WA619-03F01(rev0)- Wind Effects Letter.doc

**RE: 33 Cross Street, Double Bay – Response to Comments on
Pedestrian Wind Effects Statement**

This letter discusses the comments made by the Department of Planning on the Pedestrian Wind Environment Study of February 4 2009 (Report Ref. No. WA619-01F03(rev1)) for the proposed 33 Cross Street Development. In the first section the effects of the design changes on the expected wind conditions around the site are discussed and in the second section responses are made to specific questions raised during the consultation period.

Figure 1: Recommended strategic planting for Level 4

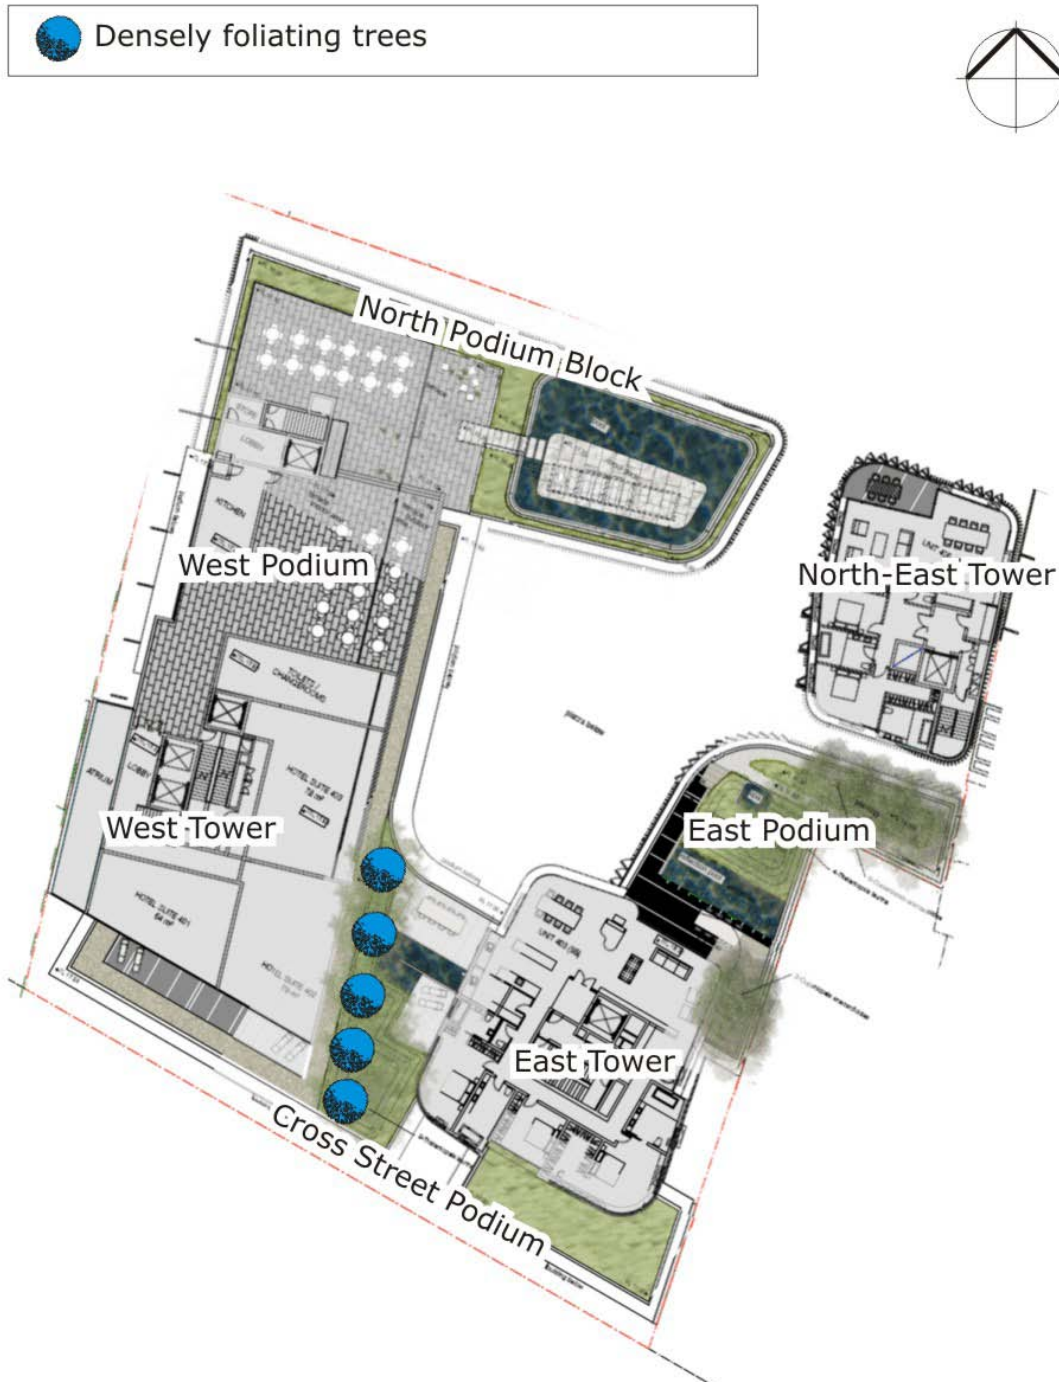
Wind conditions on the Level 4 roof terrace between the eastern and western towers may be unfavourable due to a potential funneling effect. However with the inclusion of a landscaping plan on the Level 4 terrace similar to that shown in the current design and as detailed in Figure 1, it is expected that wind conditions on this terrace will be acceptable for their intended use. The proposed impermeable balustrades/ screens will further assist in maintaining acceptable wind conditions in that area.
